ADDENDUM NO. 3
to
PLANS and SPECIFICATIONS
for

Medina River Sewer Outfall, Segment 6
SAWS Job No. 10-2502

Issue Date: August 6, 2010

TYPICAL FIBERGLASS MANHOLE DETAIL
N.T.S. - MODIFIED ON AUGUST 4, 2010

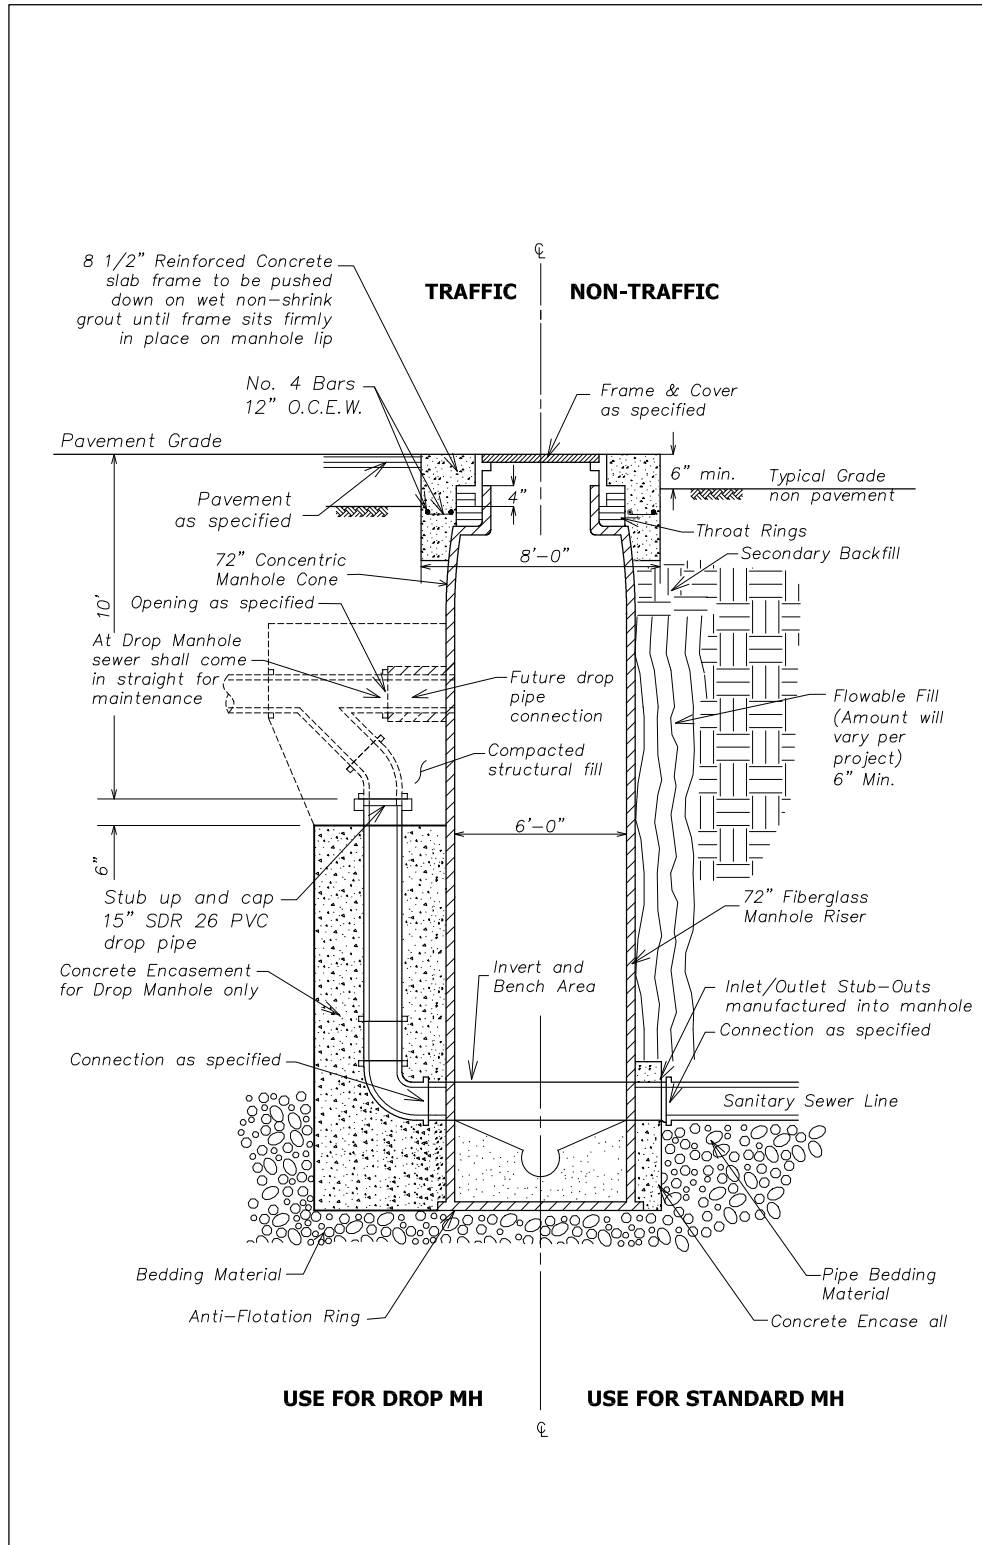
- A. Drawing No. D-12 – Delete Detail D-12/A and replace with Attachment 1, Detail D-12/A.

Question: The manhole detail on Sheet D12 indicates that flowable fill will be required outside the manhole at a minimum thickness of six inches. Given the depth of the manholes on this project and the amount of soil that will be removed around each location to safely install them, how far away from each manhole should this flowable fill extend?

Answer: The intent of the detail is to provide flowable fill in confined areas where backfill compaction requirements can not be obtained such as small confined areas around manholes. Flowable fill would typically be required where the trench wall is vertical. The limits of the flowable fill shall be wherever the trench wall slopes back enough for compaction equipment to work around the manhole and obtain the required backfill compaction requirements. Contractor shall perform compaction tests in backfill around manholes to verify compaction requirements are being obtained.
